City of Santa Barbara California

PLANNING COMMISSION STAFF REPORT

REPORT DATE: May 14, 2008
AGENDA DATE: May 22, 2008
PROJECT ADDRESS: 1837 ½ El Camino de la Luz (MST2002-00214/CDP2002-0008)
TO: Planning Commission
FROM: Planning Division, (805) 564-5470
 Jan Hubbell, AICP, Senior Planner *JH*
 Dan Gullett, Associate Planner *DG*

The purpose of the Planning Commission hearing is to consider certification of the proposed Final Environmental Impact Report (EIR) and approval of the requested discretionary applications for a proposed single-family residence at 1837½ El Camino de la Luz.

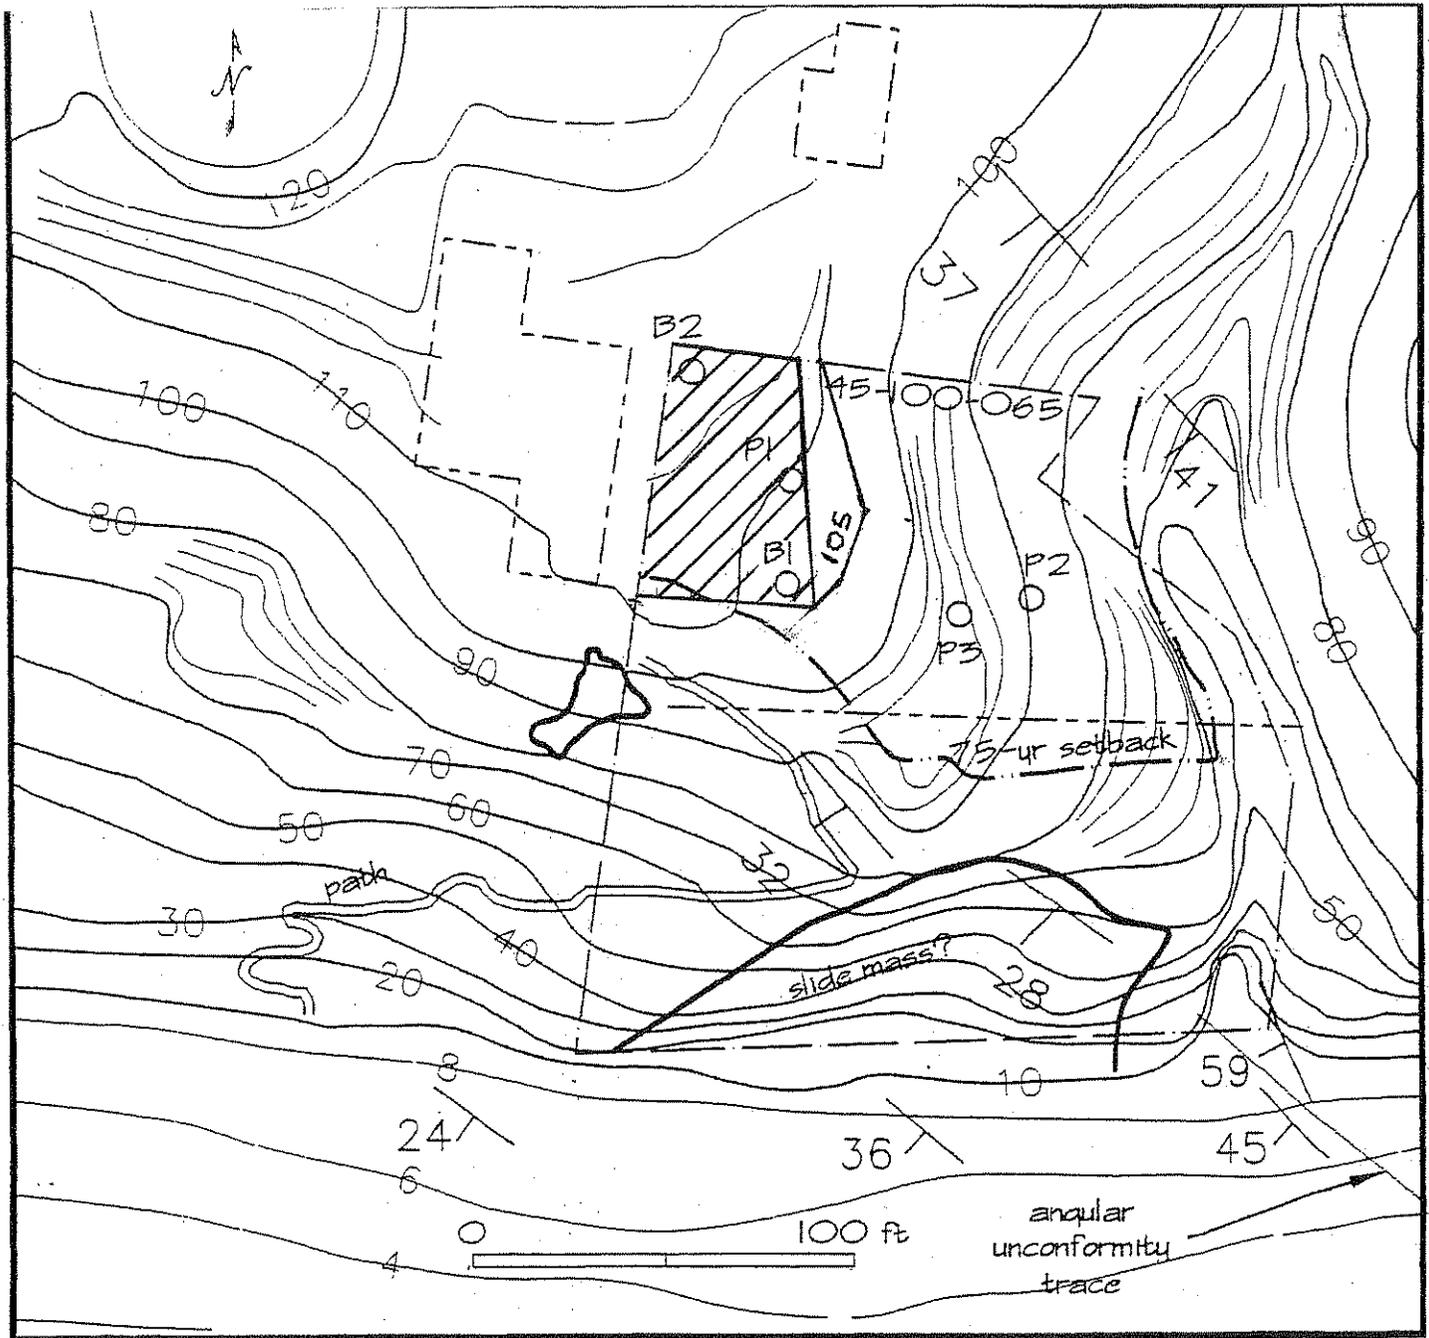
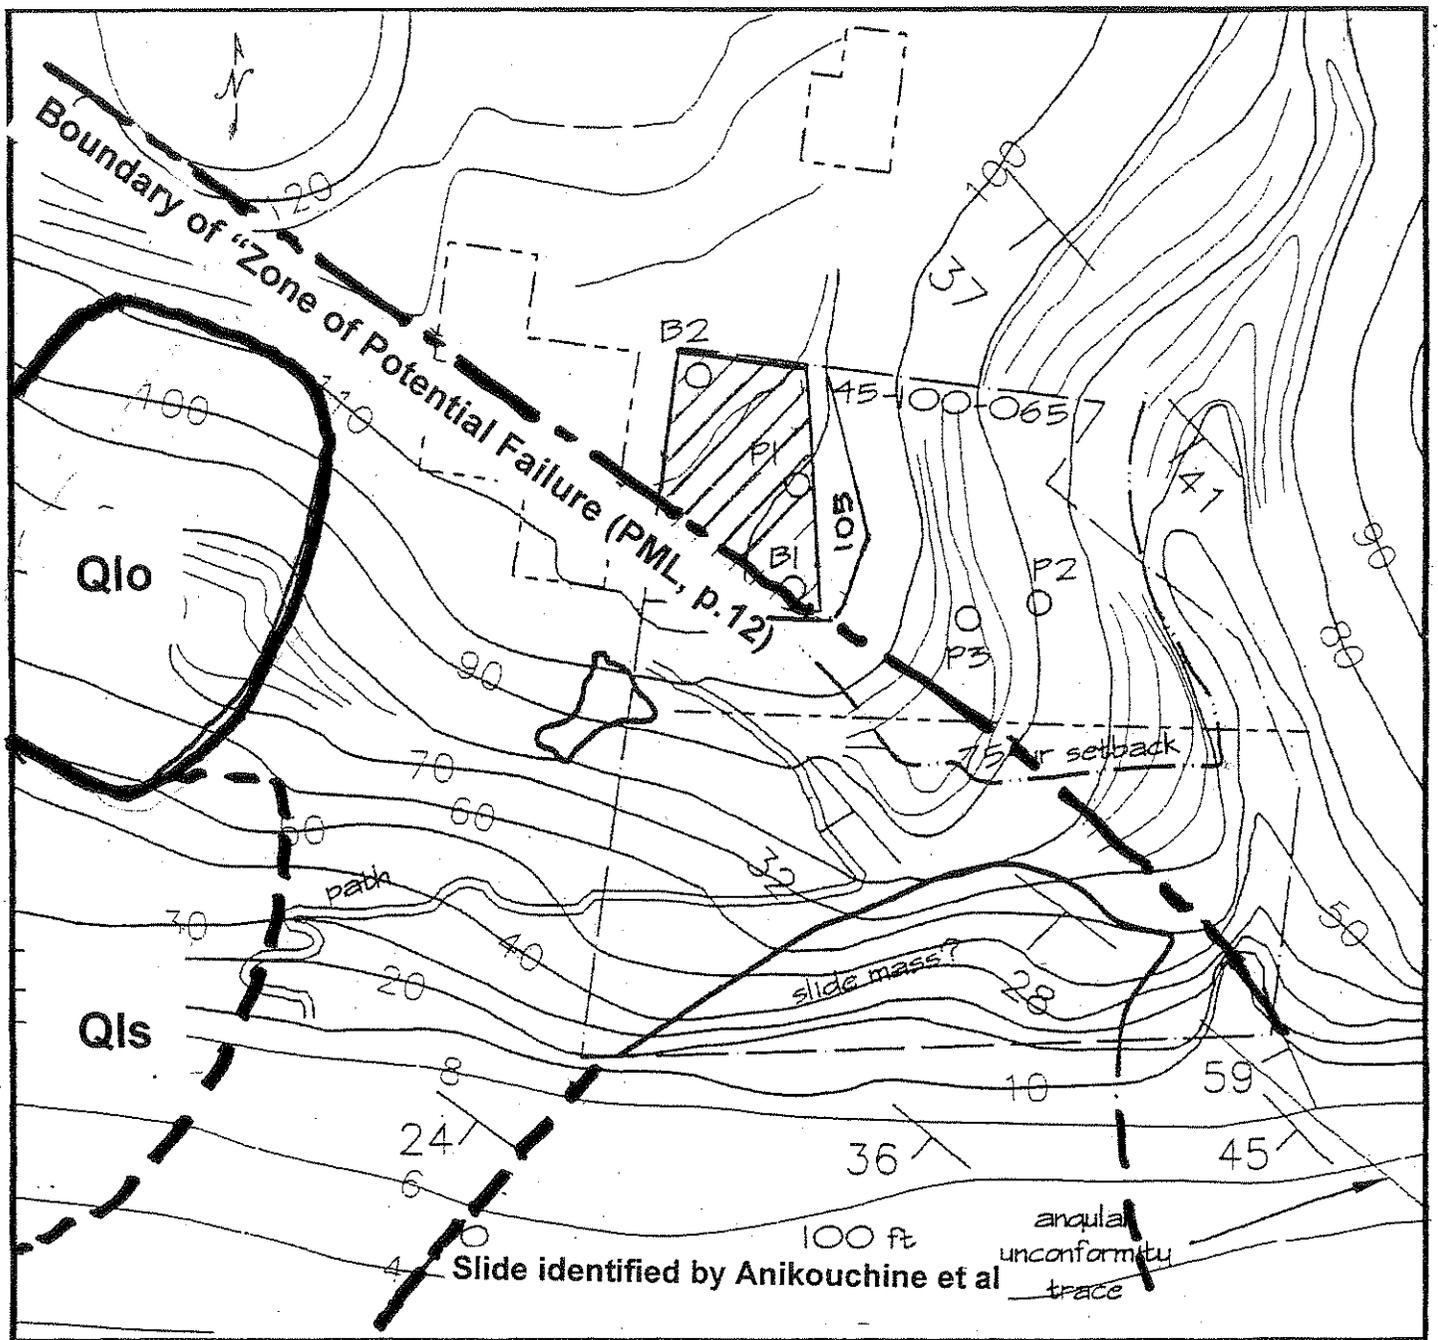
1. The report reads "*The building envelope chosen by (Dr.) Smith is just east of the paved area (cross-hatched on Fig. 1). He declared that the paved area was unsuitable as a building site because of an open fissure that he observed from the beach and which projected northward*". The cross-hatched area drawn by Dr. Anikouchine is clearly in the wrong place. Dr. Anikouchine has drawn this suitable building pad on top of the existing paved area. The proposed house and building envelope straddle the paved area and the incorrectly plotted pad by Dr. Smith. See our Figure A.

2. Figure 1 omits a line indicating a "**Boundary of 'Zone of Potential Failure'**" in the Pacific Materials Lab report prepared for the City of Santa Barbara following the 1978 landslide of over 1 million cubic yards just east of the subject parcel. This line coincided with Dr. Smith's observance of an open fissure in the bedrock. See our exhibits B and C.

“ The building envelope chosen by Smith is just east of the paved area (cross-hatched on Fig. 1). He declared that the paved area was unsuitable as a building site because of an open bedding fissure that he observed from the beach and which projected northward”. Anikouchine report March 2005.

Note that the cross-hatched area on Figure 1 is the major part of the paved area. The paved area is outlined by the 105 ft contour. The drawing and the text are contradictory.

1. Mr. Franco is mistaken about what the hachuring on the map in Figure 1 of my report represents. My report indicates that the cross-hatched area is the paved parking area, not the proposed building envelope.

2. The line Mr. Franco refers to is identified in the Weaver report in the 6 March 1978 Pacific Materials Laboratory, Inc. document as a "Potential short term plain (sic) of failure" (see legend of cross section A-A'). Weaver refers to a "Zone of Potential Failure" in the text of his report. A short term failure along the indicated plane has not occurred for 30 years. Apparently Dr. Weaver's surmise regarding the likelihood of imminent failure along the plane was in error. Furthermore, the dot-dash line Weaver put on his map to represent the failure plane does not extend as far to the east as Mr. Franco's annotated exhibits (his Figures B and F) indicate.

Figure 3. Topographic profiles through the subject parcel. The numbers indicate the local slope in degrees. Note the rounded, convex-upward shape of the the area above the sea cliff in both profiles.

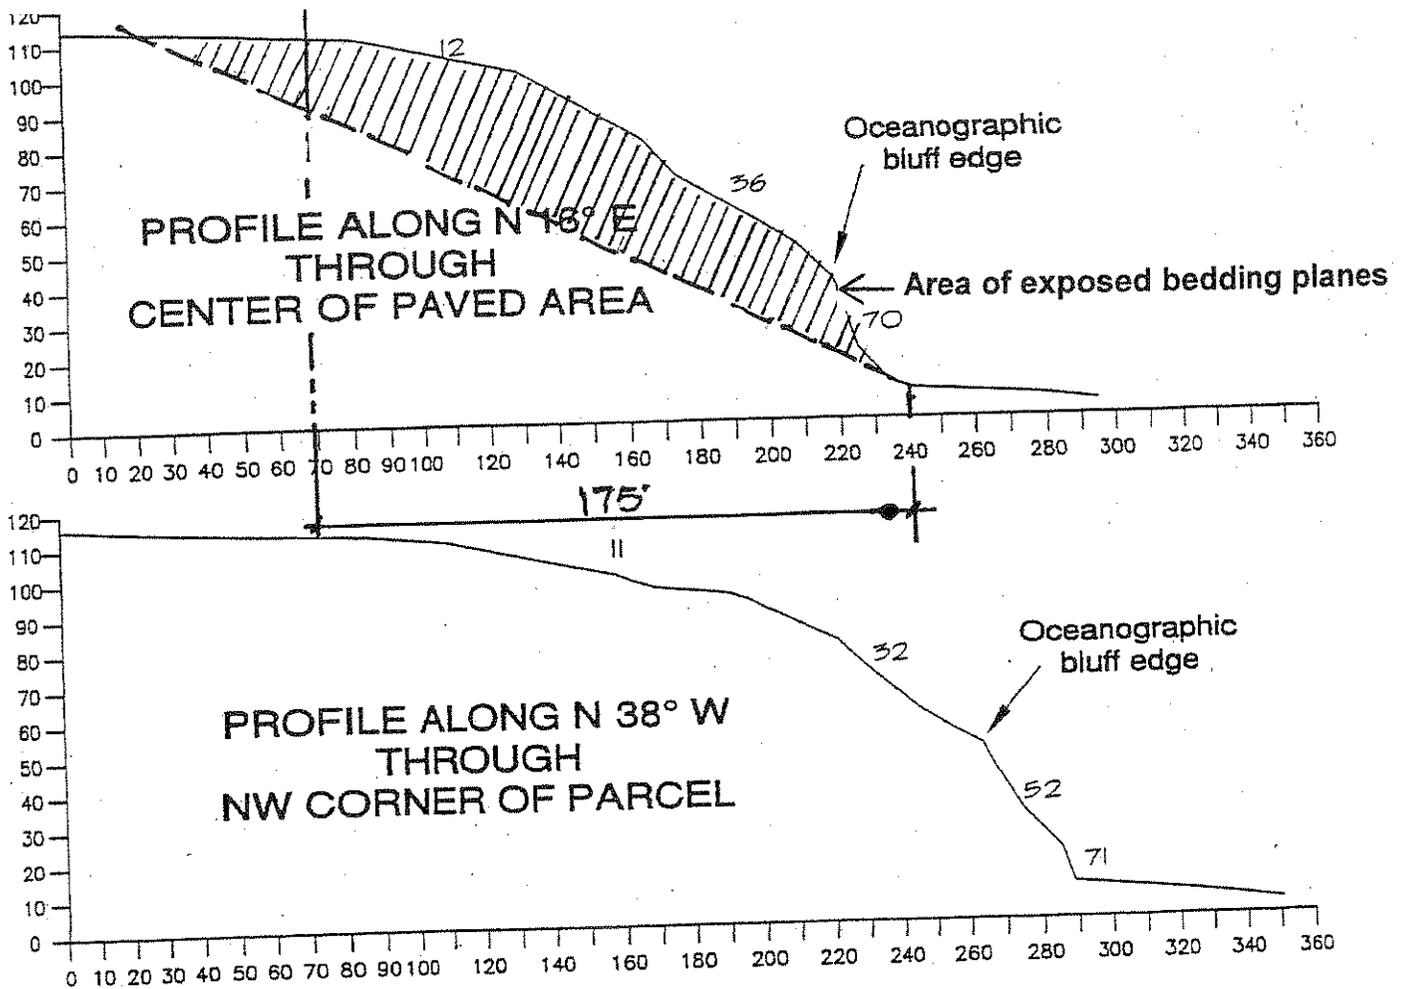
17. Page 10-16 Answer 3-4 Dr. Anikouchine drew two profiles along which his slope stability analysis was calculated. Dr. Anikouchine's two profiles do not accurately depict the location of the parcel. The profiles shown on Figure 3, page 9 of his report indicate a horizontal dimension of 294 ft along the N 16 E axis. The actual dimension of the subject parcel is 170.71 ft along the West property line, and 175 ft along N 16 W. The section does not indicate the location of the proposed project and therefore leads to the wrong conclusion that the project is located safely atop an expansive terrace. Our Figure D correctly shows the location of the subject property line.

Note: Crosshatched area represents the land mass above the lowest unsupported bedding plane susceptible to sliding.

The subject property along N 16 E is only 175 ft deep.

Permitted Building Envelope

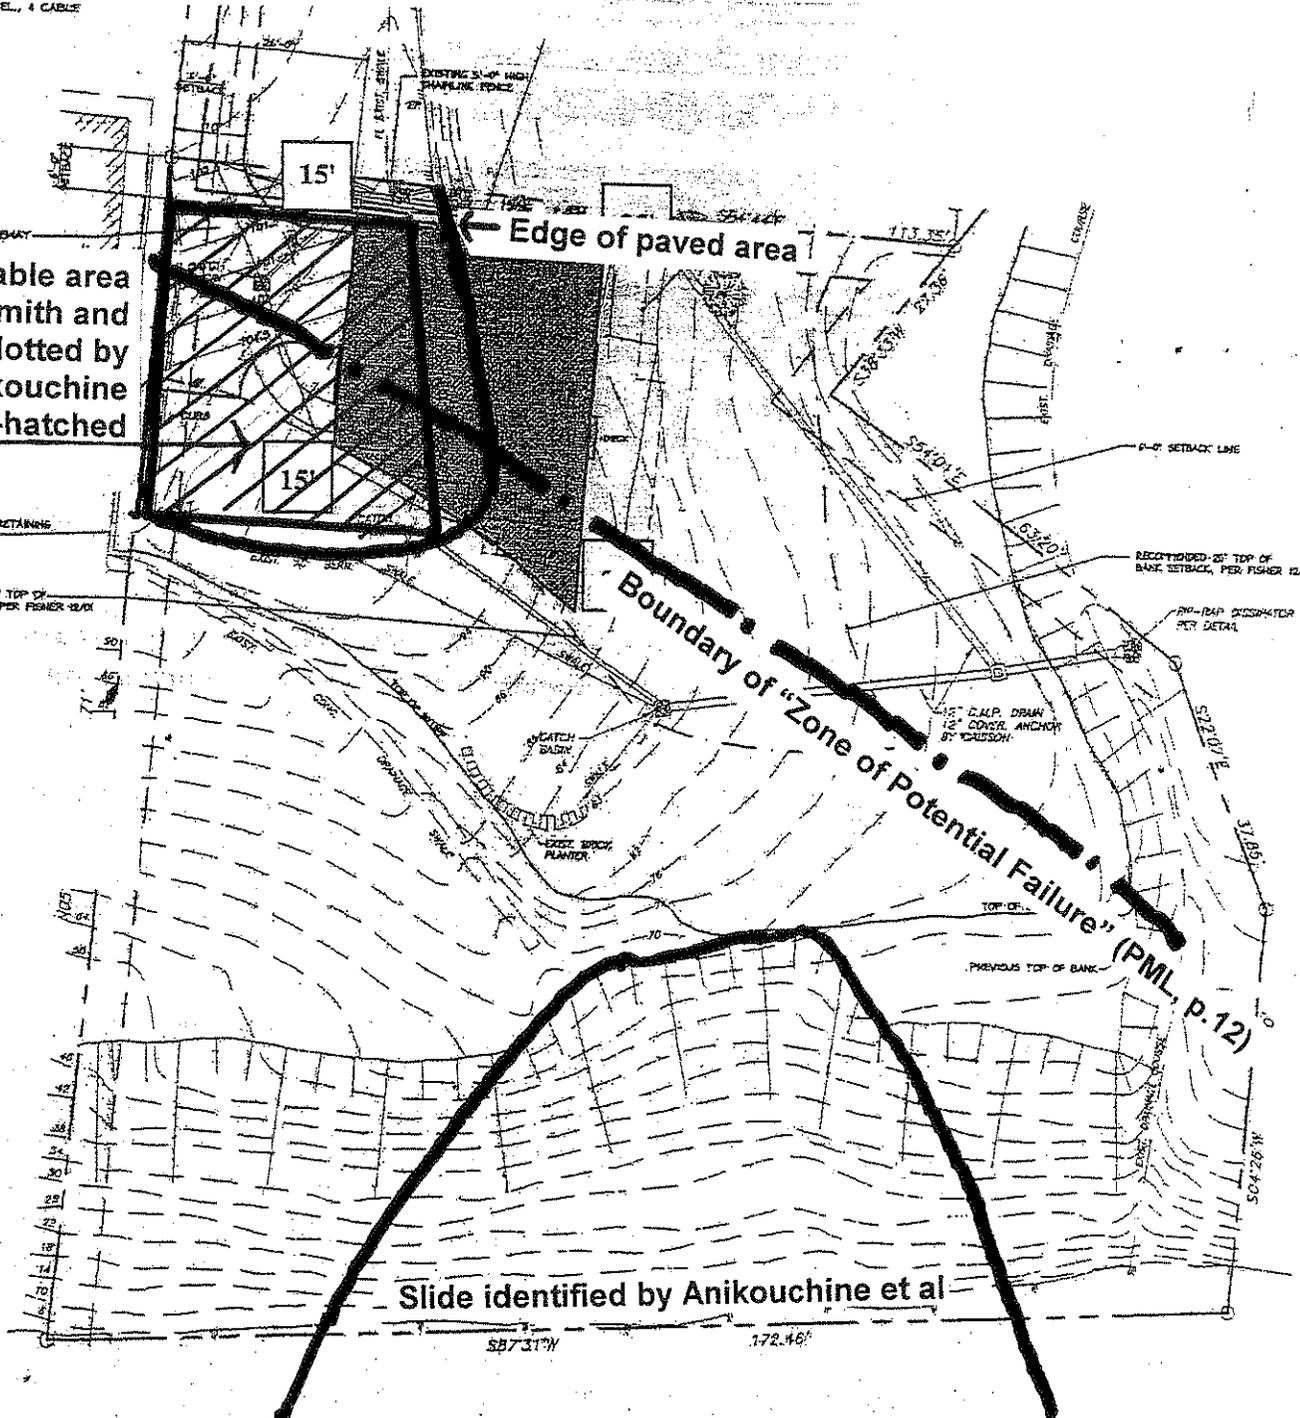
5. Figure 3.3.1 shows a plan different that the most recent plan submitted to the ABR for review. The square footages shown on 3-5 are wrong.
6. Figure 3.3.2 shows an East elevation of 35 ft and a West elevation of 21 ft. The "*Permitted Building Envelope*" indicates comparable elevations of 25 ft and 15 ft. Does the building envelope slope from 15 ft down to the 25 ft West elevation? On page 5.1-23 of the report, reference is made to a mitigating 5 ft. reduction in height along the West elevation. This should be corrected; $21 - 15 = 6$ ft.

Unbuildable area per Smith and incorrectly plotted by Anikouchine
Cross-hatched

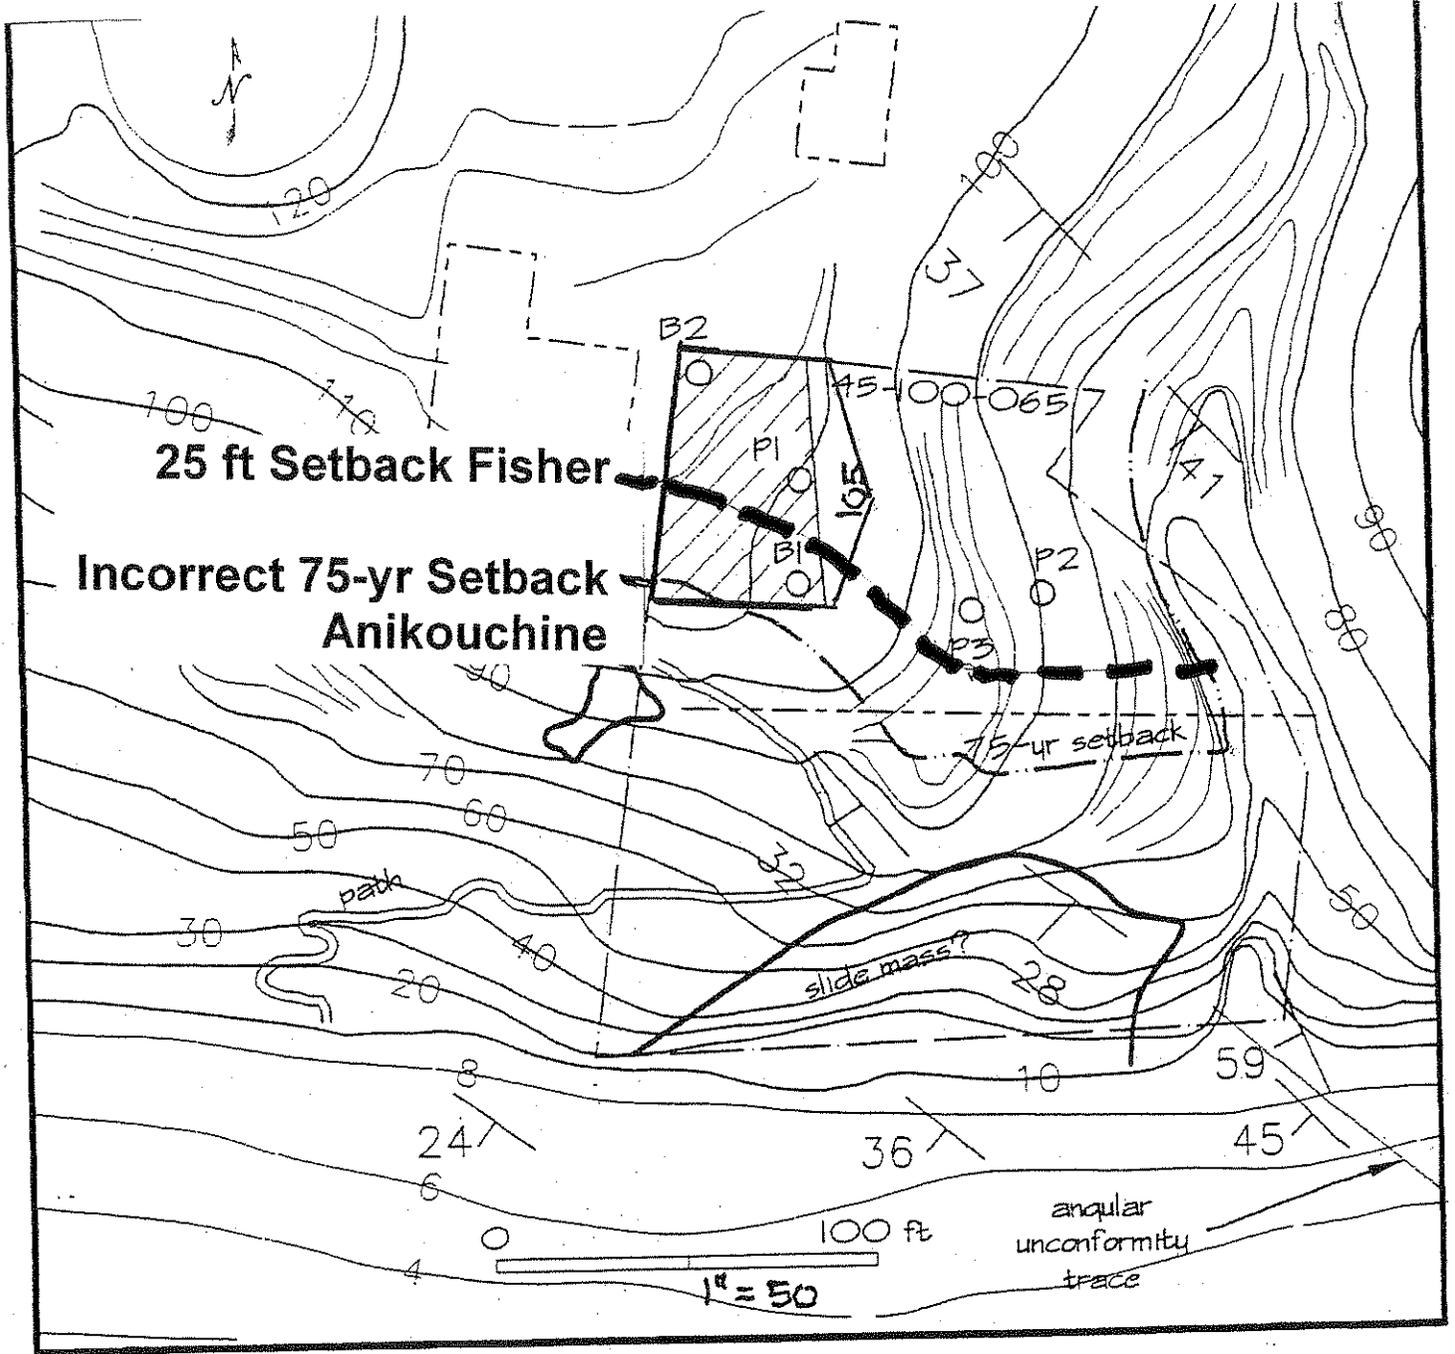
3. Dr. Anikouchine minimizes the impact of the landslide at the southeast corner of the subject parcel by stopping the designation of the slide at the southerly property line. In fact, the slide extends to the ocean. When projected on his Figure 1, the impact of the slide is significantly greater than implied by Dr. Anikouchine. See our Figure B.

Note: Anikouchine incorrectly plotted the top of bluff as defined by Fisher. He calls it "75-yr setback".

3. Mr. Franco modified Figure 1 of my report to show landslide boundaries extending seaward in his Figures B and F. The modified figures are incorrect. Figure 2 in my report is a photograph of the wave-cut platform offshore of the slide at low tide. Figure 2 shows clearly that none of the present platform was involved in the slide.

14. The setback line shown on Figure 1 in my report is to illustrate that marine erosion rates do not apply at verges not being actively attacked by waves. Such verges are attacked by terrestrial and/or bluff failure. Terrestrial erosion proceeds at markedly slow rates. Bluff failure proceeds episodically such that a characteristic rate of bluff retreat is probabilistic and should be considered accordingly. Nonetheless, the method of evaluating historical shoreline retreat includes inescapably the effects of bluff failure.
